Town of Hilton Head Island Regular Design Review Board Meeting

DESIGN TEAM/DRB COMMENT SHEET

PROJECT NAME: Golf Academy – NEW DEVELOPMENT FINAL

DRB#: DRB-001268-2015

LANDSCAPE PLAN

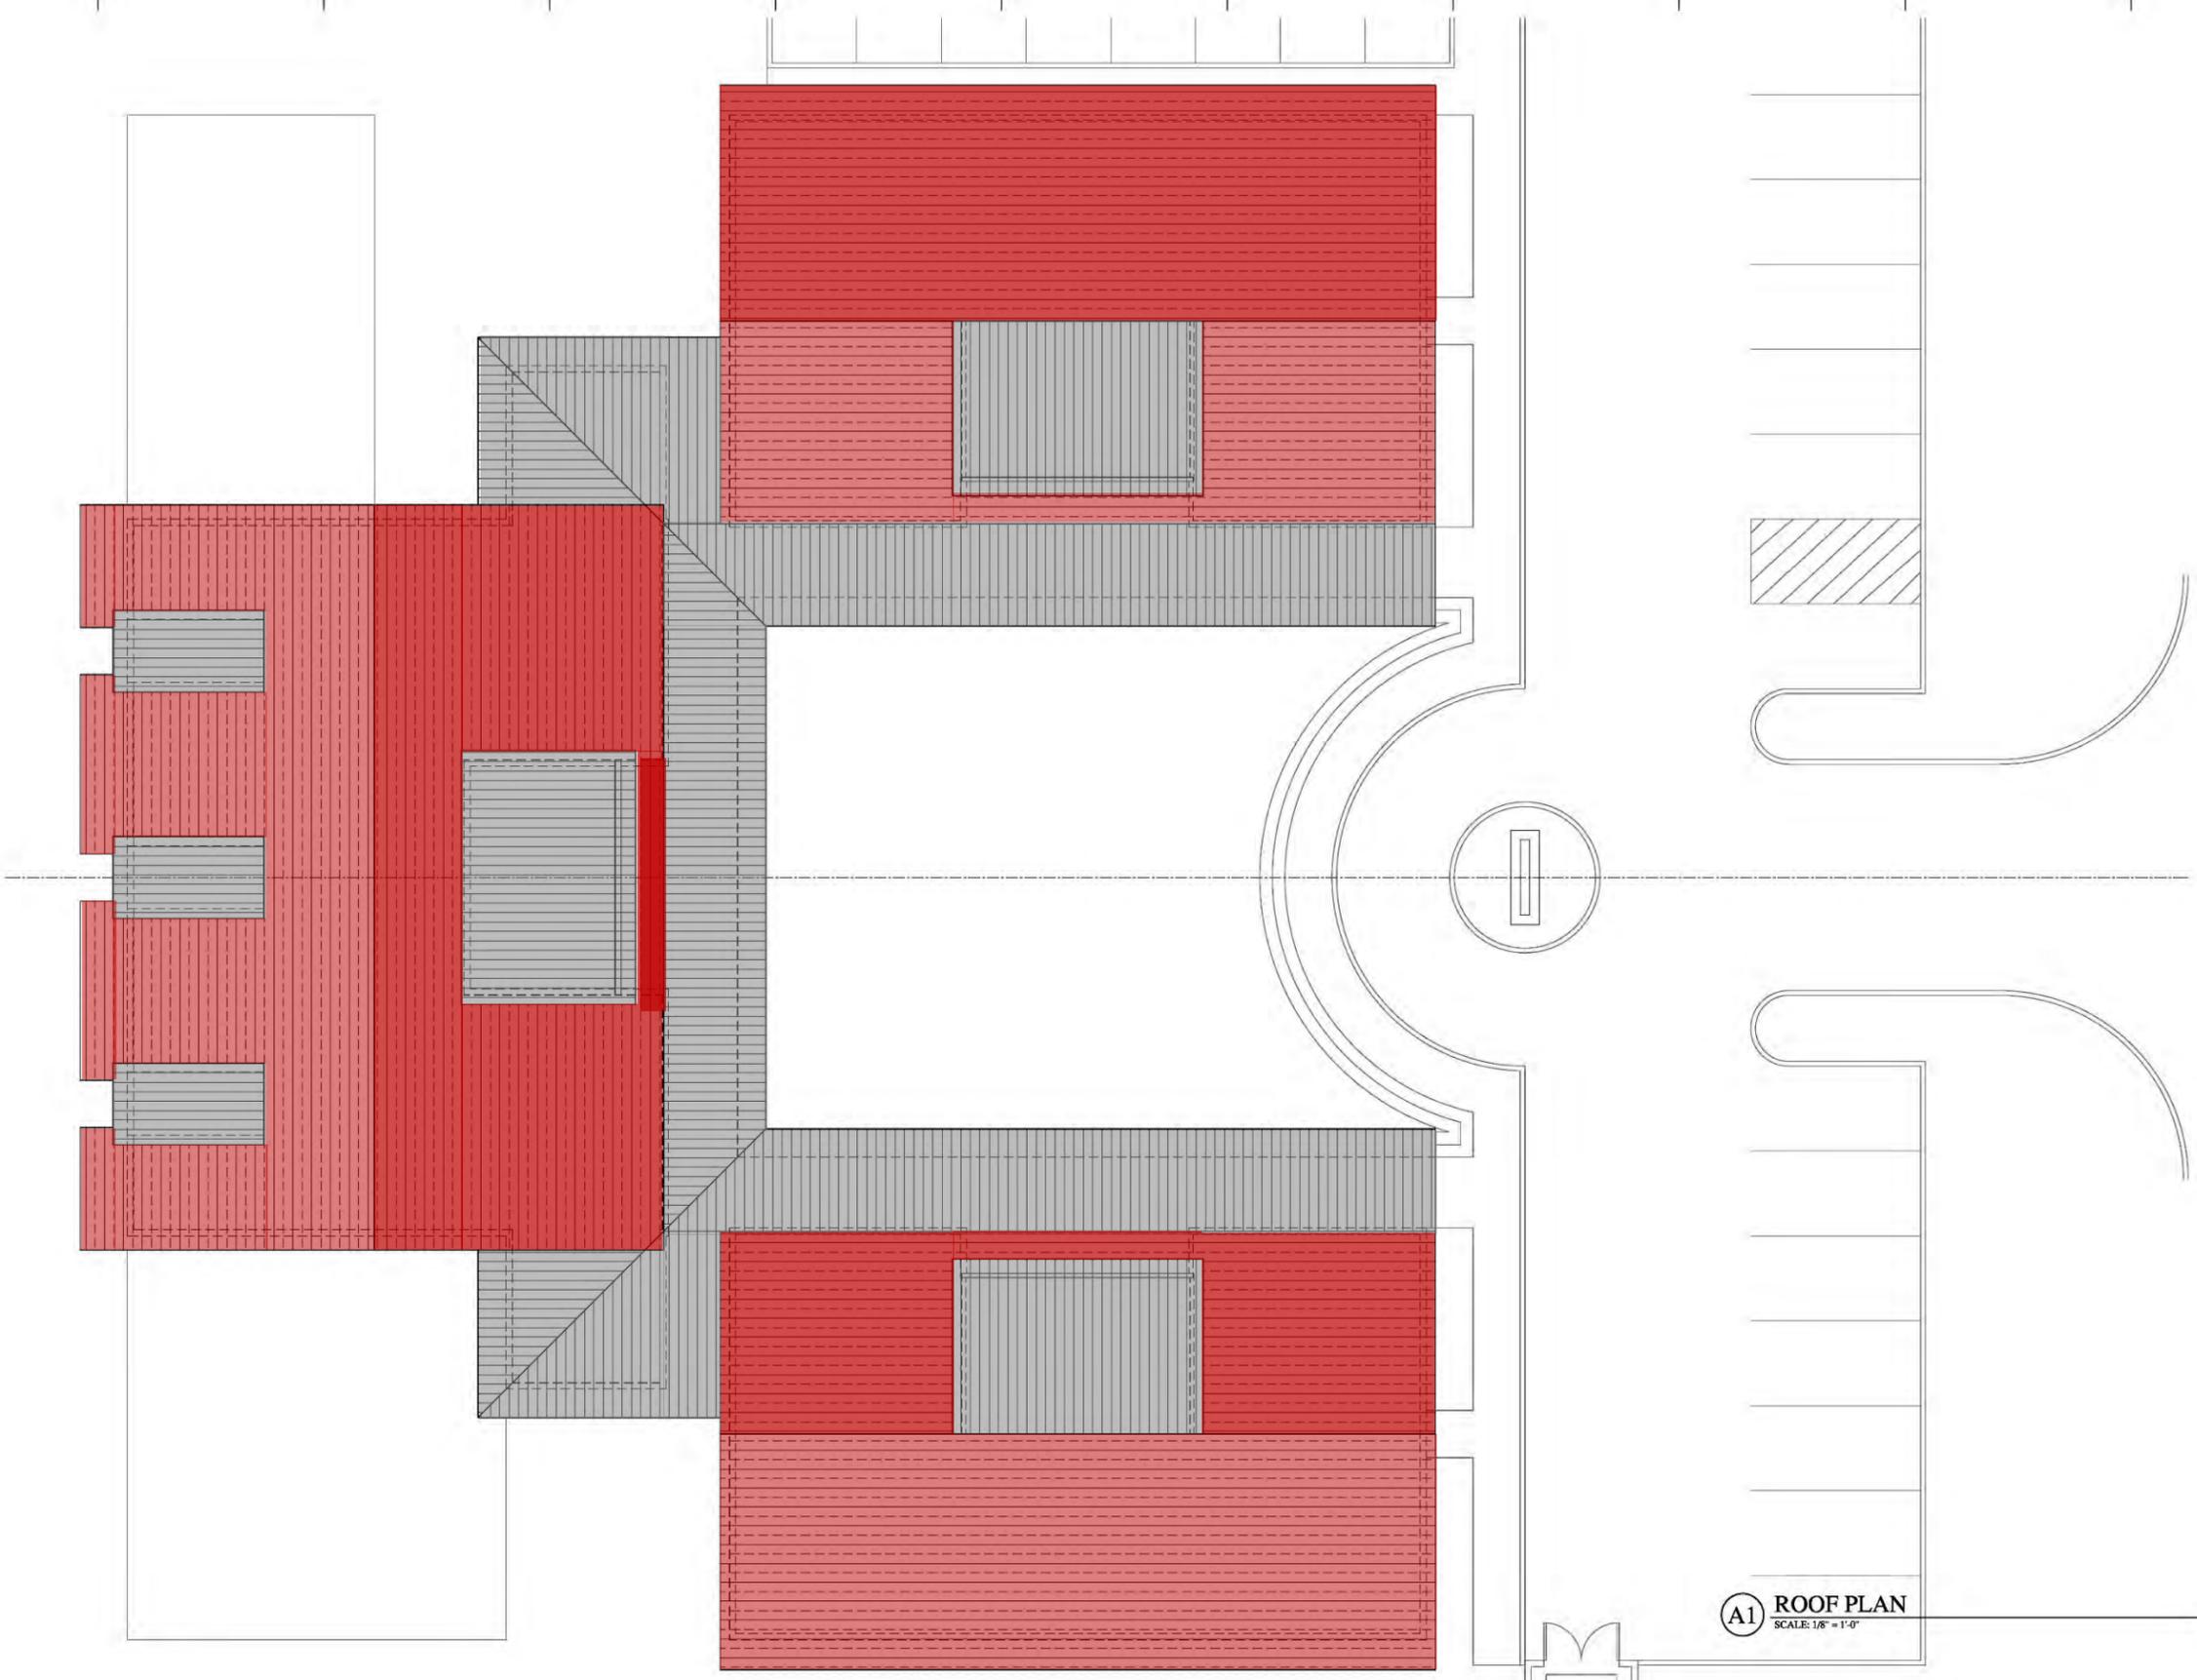
1. Landscape plan should be revised for review/approval by DRB and should address plant spacing (especially in parking lot islands), to add significant landscaping between parking/sidewalks and buildings, to add landscape screen at dumpster, to add more native plants, to reflect trees/landscape material to remain and trees to be removed, etc.
2. Cut sheets for site lighting and building lighting should be provided for review/approval by DRB.
3. Site plan should be updated for review/approval by DRB to clarify all proposed site elements including courtyard. Provide details for all site elements including fence, gates, dumpster, and monument sign.
4. Consider a darker color (i.e. beige) for the building that is more in keeping with Beach City Road area.

DESIGN GUIDE/LMO CRITERIA	Complies Yes	No	Not Applicable	Comments or Conditions
Treats the Landscape as a major element of the project	<input type="checkbox"/>	<input checked="" type="checkbox"/>	<input type="checkbox"/>	
Provides Landscaping of a scope and size that is in proportion to the scale of the development	<input type="checkbox"/>	<input checked="" type="checkbox"/>	<input type="checkbox"/>	
Landscape is designed so that it may be maintained in its natural shape and size	<input checked="" type="checkbox"/>	<input type="checkbox"/>	<input type="checkbox"/>	
Preserves a variety of existing native trees and shrubs	<input type="checkbox"/>	<input type="checkbox"/>	<input type="checkbox"/>	Existing trees in buffers proposed to remain. Most other existing trees proposed to be removed.
Provides for a harmonious setting for the site's structures, parking areas or other construction	<input type="checkbox"/>	<input checked="" type="checkbox"/>	<input type="checkbox"/>	Parking lot islands over planted. No planting shown at buildings.

NORTH ELEVATION (BEACH CITY ROAD)
SCALE: 1/8" = 1'-0"
JPGA-ELE.DWG 1

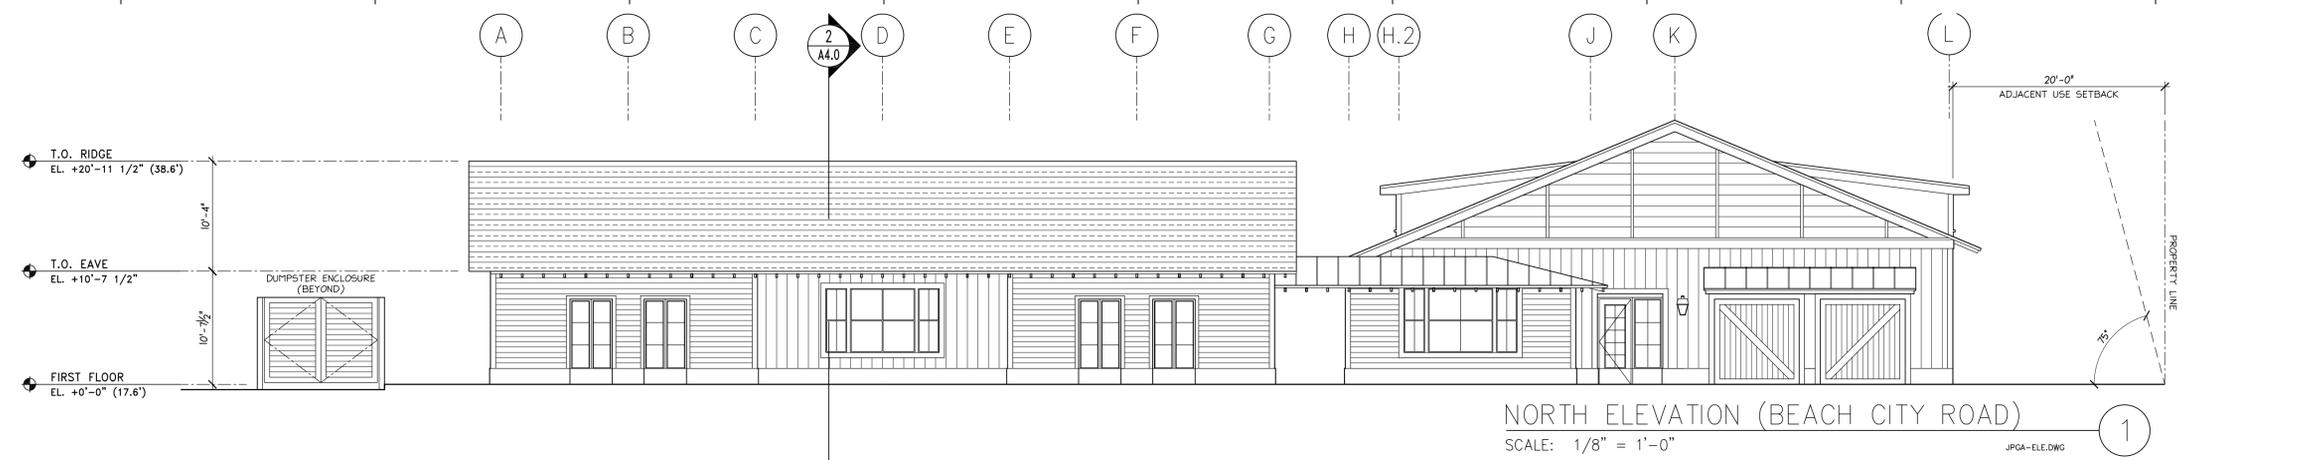
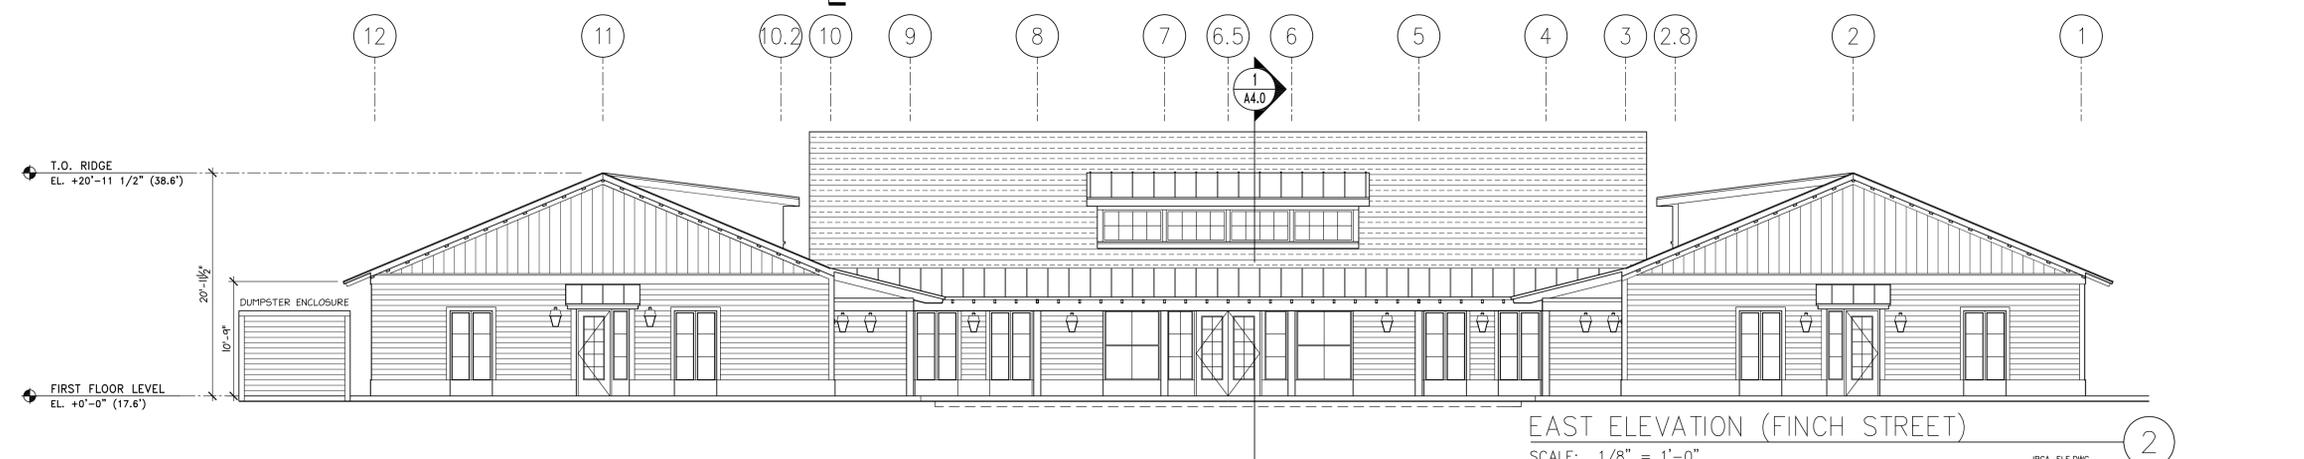
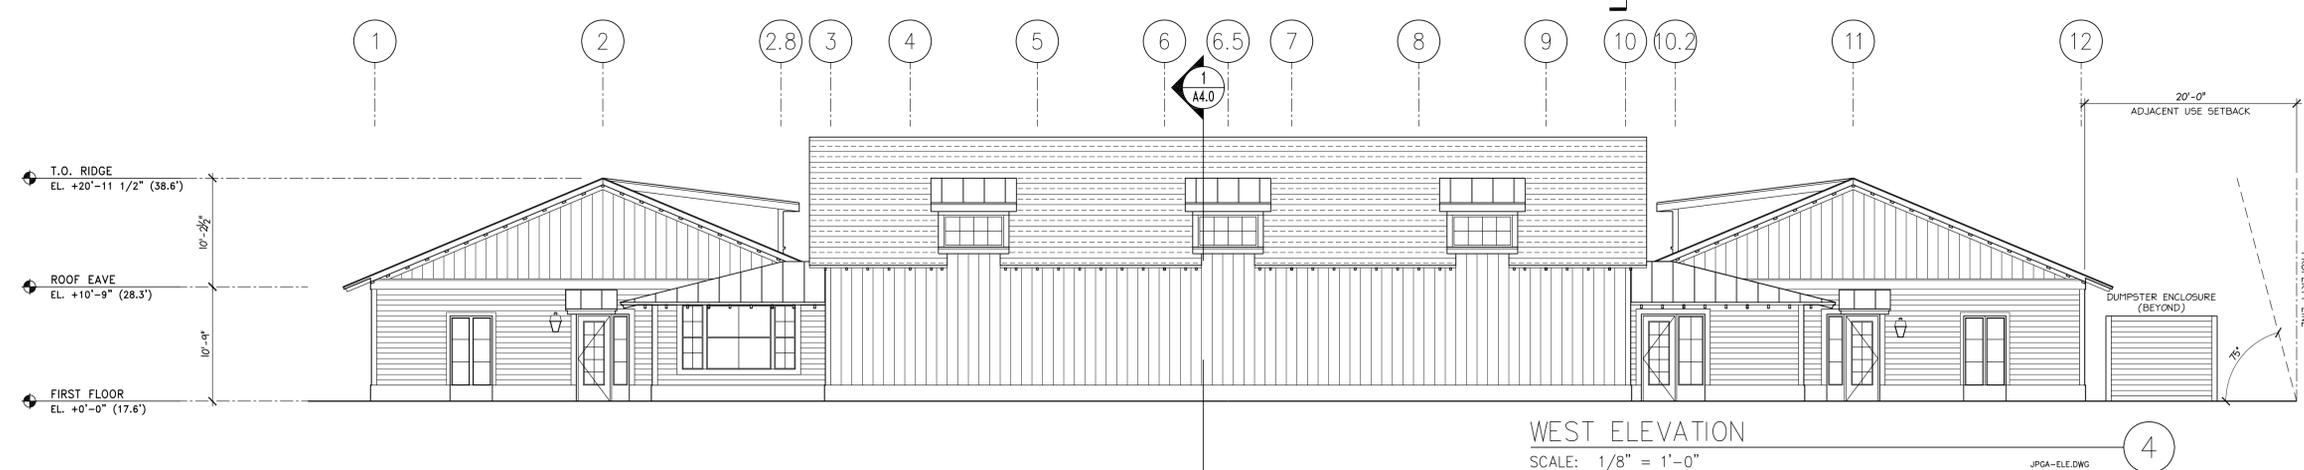
ARCHITECTURAL DESIGN				
DESIGN GUIDE/LMO CRITERIA	Complies Yes	No	Not Applicable	Comments or Conditions
Structure is designed to be appropriate to the neighborhood	<input checked="" type="checkbox"/>	<input type="checkbox"/>	<input type="checkbox"/>	
Promotes pedestrian scale and circulation	<input checked="" type="checkbox"/>	<input type="checkbox"/>	<input type="checkbox"/>	
Design is unobtrusive and set into the natural environment	<input type="checkbox"/>	<input checked="" type="checkbox"/>	<input type="checkbox"/>	Majority of existing trees are removed and few trees are proposed.
Utilizes natural materials and colors	<input type="checkbox"/>	<input checked="" type="checkbox"/>	<input type="checkbox"/>	Building color (SW 6385 'Dover White') and trim color (SW 7006 'Extra White') are not nature

blending and are too light/bright for neighborhood, especially due to lack of many canopy trees.
Avoids distinctive vernacular styles	<input checked="" type="checkbox"/>	<input type="checkbox"/>	<input type="checkbox"/>	
Design is appropriate for its use	<input checked="" type="checkbox"/>	<input type="checkbox"/>	<input type="checkbox"/>	
All facades are have equal design characteristics	<input checked="" type="checkbox"/>	<input type="checkbox"/>	<input type="checkbox"/>	
Avoids monotonous planes or unrelieved repetition	<input checked="" type="checkbox"/>	<input type="checkbox"/>	<input type="checkbox"/>	
Has a strong roof form with enough variety to provide visual interest	<input checked="" type="checkbox"/>	<input type="checkbox"/>	<input type="checkbox"/>	
Minimum roof pitch of 6/12	<input type="checkbox"/>	<input checked="" type="checkbox"/>	<input type="checkbox"/>	All buildings 5:12 (asphalt shingle), porch roofs 3:12 (metal standing seam), and dormer roofs 1.5:12 (metal standing seam)
